Technical change to SAIL-VSA-X.XU-230 (189100XXXX)

The products listed below will be changed after a transition period. Please pass on this Product Change Notification (PCN) to your employees and, if applicable, to your customers.

Dimensions Old

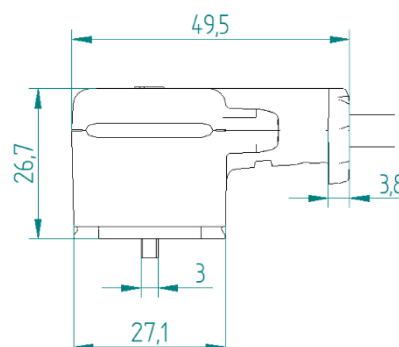
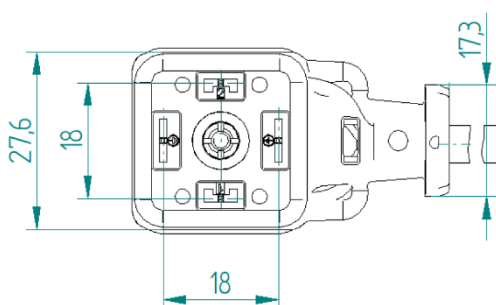
Due to a spontaneous discontinuation of the circuit board, the connector design had to be modified. This resulted in changes to the dimensions and arrangement of the contacts.

Pin assignment old

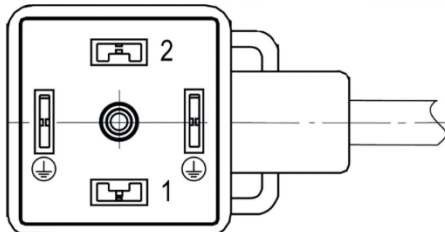
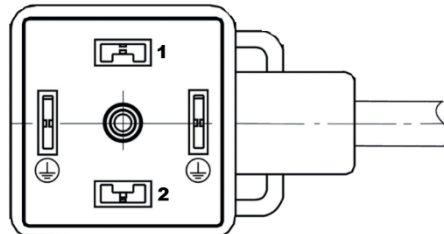
Due to a change in the connector design, the varistor installed in the articles can only be installed with the contact carrier rotated by 180°, as otherwise errors in series operation are to be expected. For this reason, pin 1 and pin 2 are swapped.

Since the pin assignment is permanently installed on the contact carrier in the tool, it will remain identical to the old version. Therefore, please note the following change in the assignment of the wire colors of the connection cable:

Pin	Aderfarbe Bisher/ Wire Color Old	Aderfarbe neues / Wire Color New
1	Braun / Brown / BN	Blau / Blue / BU
2	Blau / Blue / BU	Braun / Brown / BN
PE	Grün Gelb / Green Yellow / GN YE	Grün Gelb / Green Yellow / GN YE
